**Department of Energy**  
Savannah River Operations Office  
P.O. Box A  
Aiken, South Carolina 29802

**SUBJECT: Margin of Seismic Safety for Postulated Seismic Events**

## Actinide Packaging and Storage Facility (APSF) Seismic Verification Study

## APSF Seismic Verification Study Spectrum

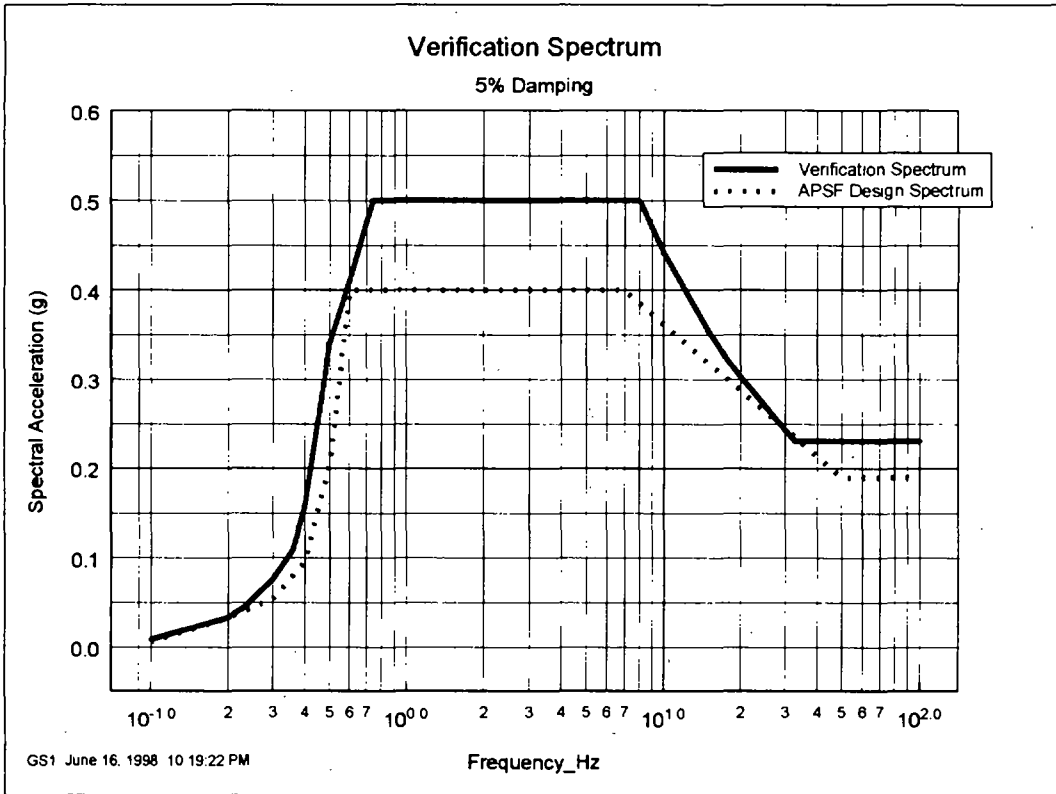
1. *The attached spectrum be used to check or challenge the APSF design and generate floor response spectra.*

The discussions between the DNFSB staff and SRS personnel on Thursday, June 11, 1998, indicated that the focus on using a verification spectrum was primarily for determining the conservatism in the APSF design, particularly with respect to in-structure vertical response spectra. Subsequent comments from the DNFSB suggest that for completeness, the spectra in the horizontal direction also be evaluated. The Verification Spectrum is the starting point to establish the extent to which seismic margin exists relative to the applicable codes and standards.

SRS will use the DNFSB Verification Spectrum to generate in-structure horizontal and vertical response spectra at the roof elevation of the Auxiliary Building and the roof elevation of the MAA building. The use of this spectrum will require that statistically independent time histories be developed with spectra compatible to the Verification Spectrum. These time histories will be applied to the elevations of the basemat of the structures.
